Declaration of Antenna Modification Process

The Antenna 868-Omni from MikroTik is delivered with standard SMA (f) connector. Antennas that are allowed to be certified for the USA market must have a unique connector (for example: RPSMA or RTSMA).

Below are the declaration photos:

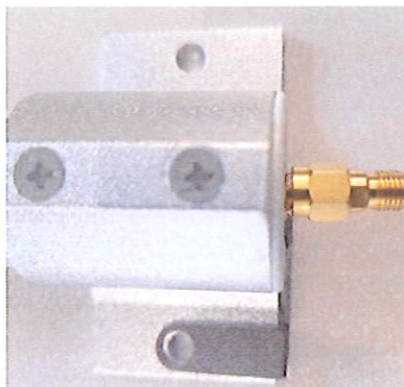
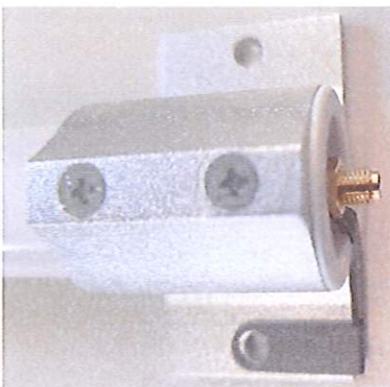
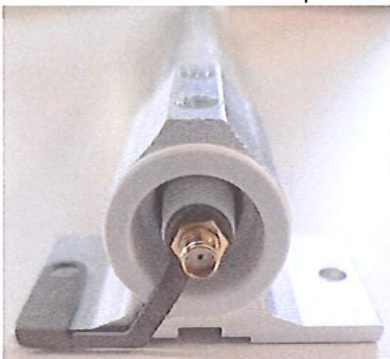
A possible solution, and according to the FCC Document "Basic Equipment Authorization Guidance for Antennas Used with PART 15 International Radiators" from 03/04/2022 relying to section II Subsection A, Subsubsection 2, Subsubsubsection a, Subsubsubsubsection ii "Antenna permanently glued with epoxy to a standard connector" a SMA-RPSMA adapter would be mounted to the antenna and glued with epoxy (2 Component Compound).

We, endiio Engineering GmbH, hereby confirm that the predefined adhesive will be applied on the above defined mounted adapter to the antenna at our factory prior to shipment to the United States of America.
